**TB 137**

**Product :** Hydraulic Maxilift models with NGV A3 valve block (GMV)

**Subject :** False NGV F51 faults logged by Nexus

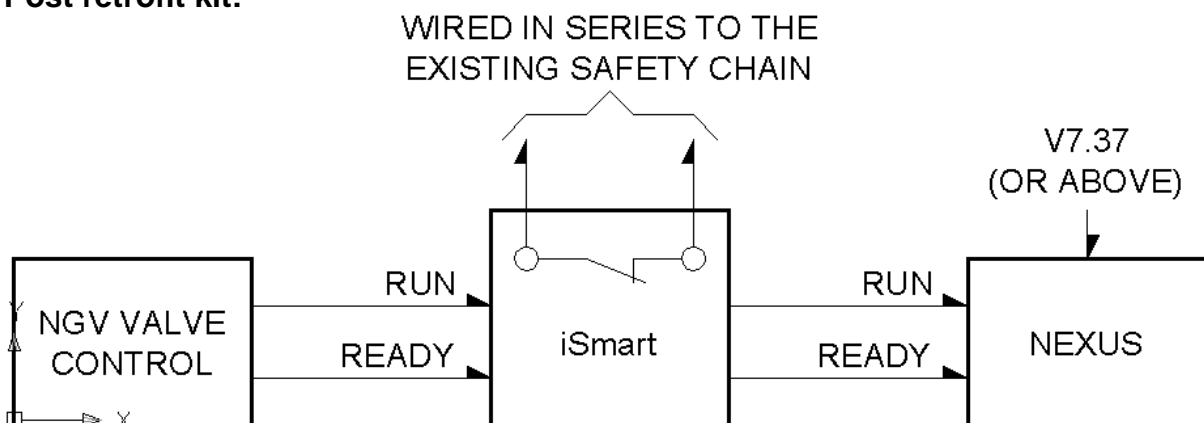
The iSmart device will assume NGV A3 monitoring responsibilities whilst providing Nexus with relevant RUN and READY signals.

If a genuine NGV A3 valve fault occurs, the iSmart will isolate the safety chain preventing further lift movement.

The NGV iSmart retrofit kit is required to prevent further faults being logged. This kit can be obtained direct from our spares department (part number = 1009274).
